# Executive Director's Recommendation

Commission Meeting: April 6, 2023

<b>PROJECT</b> <b>First Division Monument Modification</b> President's Park 17th Street and State Place, NW Washington, DC	<b>NCPC FILE NUMBER</b> 8329
	<b>NCPC MAP FILE NUMBER</b> 1.35(73.10)45633
<b>SUBMITTED BY</b> United States Department of the Interior, National Park Service	<b>APPLICANT'S REQUEST</b> Approval of preliminary and final site development plans
<b>REVIEW AUTHORITY</b> Commemorative Works Act per 40 U.S.C. § 8905	<b>PROPOSED ACTION</b> Approve preliminary and final site development plans with comments
	<b>ACTION ITEM TYPE</b> Consent Calendar

# Proposed Design

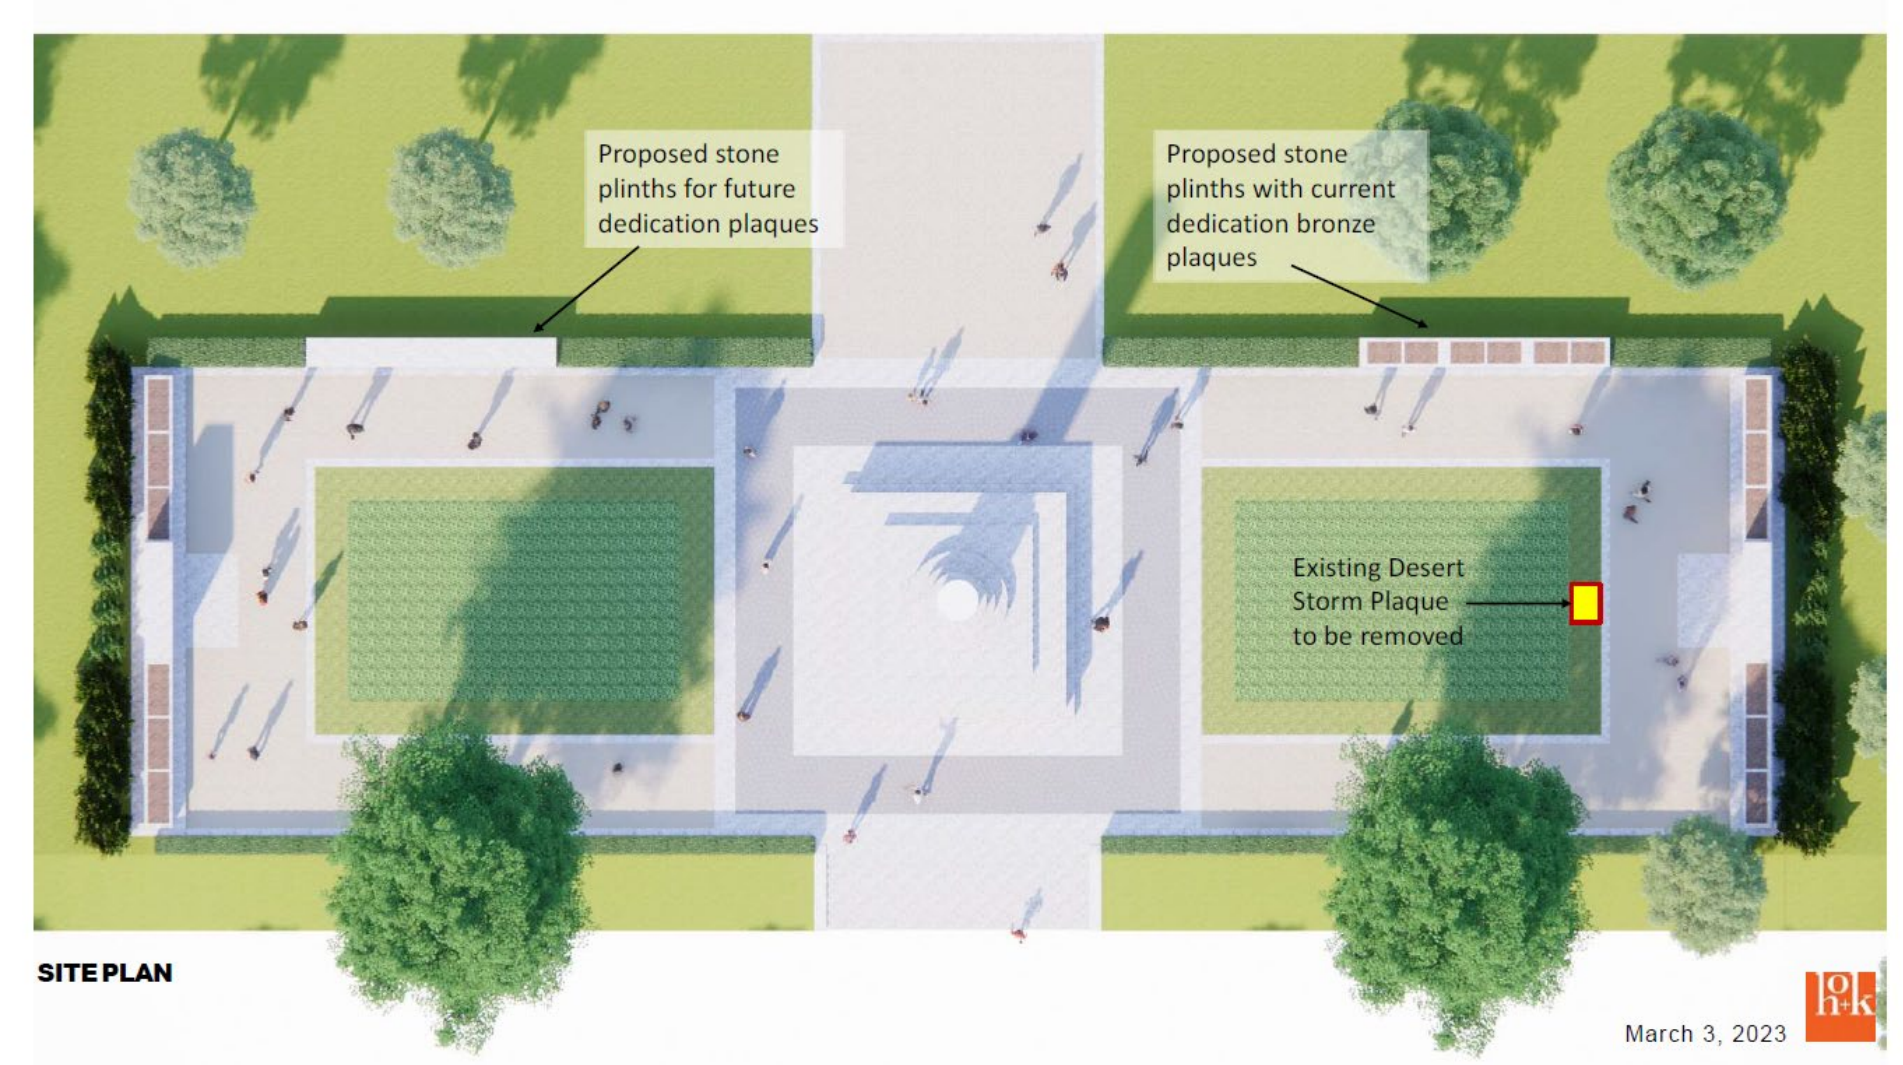
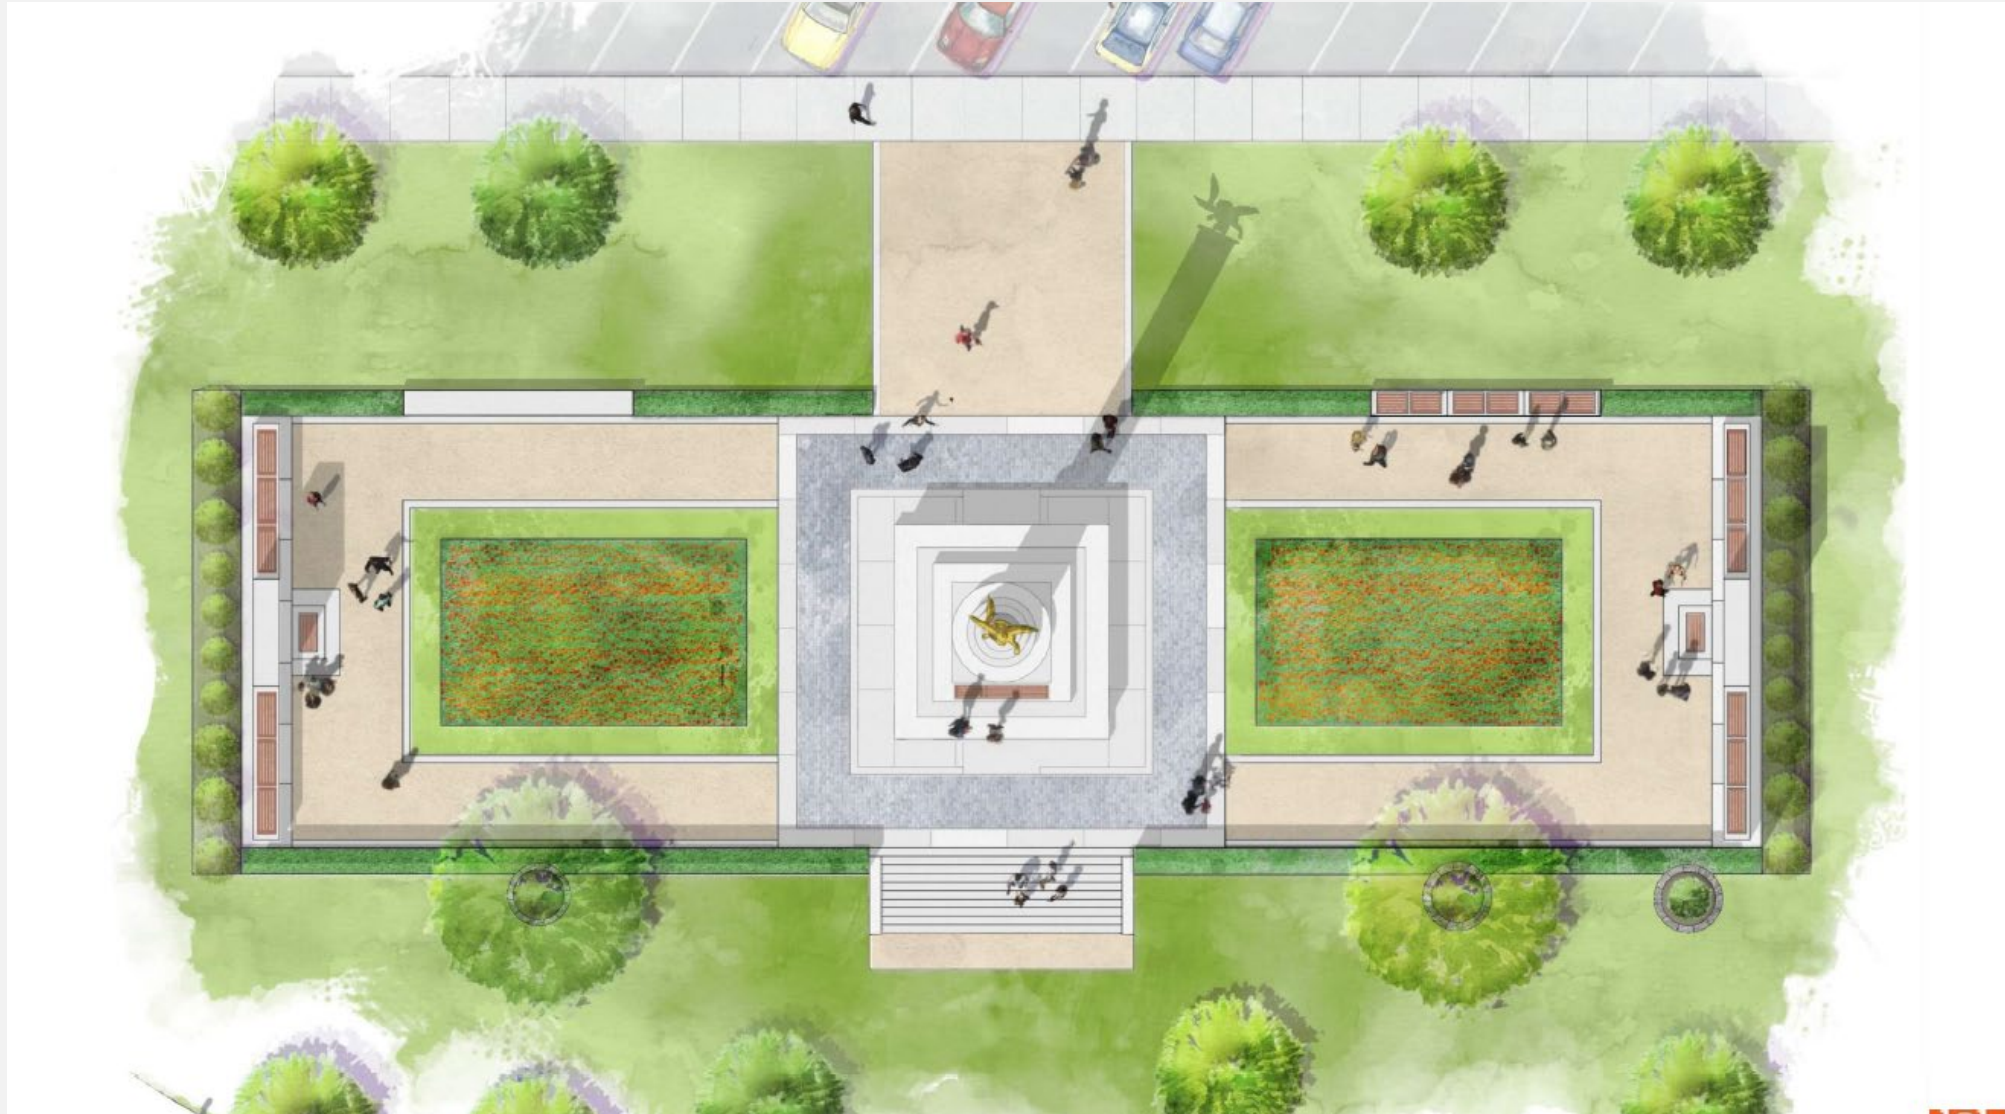
In general, staff has not identified any concerns with the proposed modifications. The three plinths with associated plaques are consistent with the design vocabulary already in use within the monument. The project will result in the loss of some hedging, but the new plinths will retain the sense of enclosure and setting of the monument, without impacting views to or from the monument. As noted previously, the monument already includes the names of First Division members from previous military operations. Therefore, proposal is consistent with the original intent and evolution of the monument. The design is also consistent with the design previously reviewed by the Commission as a concept in December 2021.

**Approves** the proposed modifications to the First Division Monument located in President's Park in Washington, DC.
